## ADDENDUM # 2

**CONTRA COSTA COMMUNITY COLLEGE**  
**D-1191 Wayfinding Signage**  
**Diablo Valley College**

**Date: June 13, 2023**

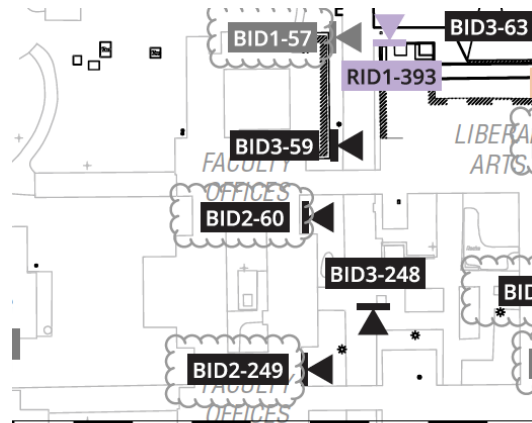
- a. The notation is correct. No typo. Sign shown on G2.36/D is used for locations 254 and 266.
16. Reference sheet G2.38/B, there are hand-written notes on the elevation drawing? Is this sign to be included? If so, are the letters 8" or 2" tall for "Fine Arts"?

- a. Disregard hand written notations.

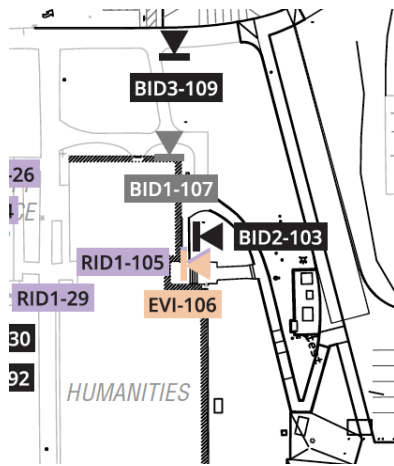
24. The following locations (for sign type "BID2") were on the site plan, but none of these locations were denoted anywhere on the individual design sheets for the "BID2" sign types: Locations # 60, # 177, #184.
- a. Location 60 is located on G2.44 B, label is incorrect and should read "Sign Location #60". Location 177 is a BID3 sign type. If you mean BID2 location 172, that is located on G2.53 D. Location 184 is a BID3 sign type. If you mean BID2 location 396, that is located on G2.57 B.
25. Sign Type "BID2", location #249 (Building Letters "Faculty Offices") is noted on designs sheet G2.44 however, I do not see a corresponding location # 249 on the site plans. Can you direct me as to where to find this Sign location on the site plan?
- a. Location 249, shown on G2.44 C, is on the site plan as "BID2-49". East side of Faculty Offices. Here is where it is labelled on the site plan...

26. Sign Type "BID2", location #103 (Building Letters "Humanities") is noted on designs sheet G2.46 however, I do not see a corresponding location # 103 on the site plans. Can you direct me as to where to find this sign location on the site plan?
- a. Location 103, shown on G2.46 A, is on the site plan as "BID2-103". Upper East side of Humanities. Here is where it is labelled on the site plan...
